APPLICATION NO.	FILING DATE	FIRST NAMED INVENTOR	ATTORNEY DOCKET NO.	CONFIRMATION NO.
10/517,940	07/18/2005	Oren Globberman	384/04315	3773
44909	7590	05/03/2010	EXAMINER	
PRTSI			HOLL, JONATHAN A	
P.O. Box 16446			ART UNIT	
Arlington, VA 22215			PAPER NUMBER	
			3734	
			MAIL DATE	
			DELIVERY MODE	
			05/03/2010	
			PAPER

Office Action Summary

DETAILED ACTION

Fig. 10

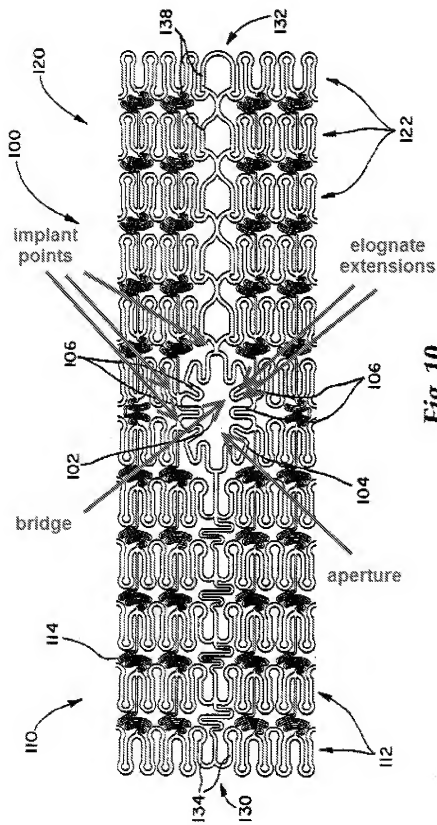
Vardi et al teach a method of distorting a cylindrical stent structure having at least two extensions coupled at a point thereof and sized and shaped to be placed in a vascular bifurcation including changing the relative position of two points on said extensions (the implant points (see annotated figure 10 above) are moved relative to each other during inflation of the delivery balloon) that are distanced from the coupling point (see figures 13a-d), but is disclosed with using a balloon to bend the extension instead of transforming, using a plurality of pre-defined hinges, tension forces applied by said changing into forces that bend said structure in a plane outside of a plane defined by said changing. Vardi et al teach transforming, using a plurality of pre-defined hinges, tension forces applied by changing the relative position of points on extensions coupled to each other into forces that bend the extensions outside of a plane defined by the changing (i.e., without the use of a balloon; see figures 3-4; column 4, line 53 – column 5, line 9). It would have been obvious to a person having ordinary skill in the art at the time of the invention to modify the method of Vardi et al to transform, via a plurality of hinges, tension forces applied by said changing into forces to bend said extensions in a plane outside of a plane defined by the changing, in view of Vargas et al, in order to simplify delivery of device by obviating the need for a balloon to flare the extension in a branch vessel.
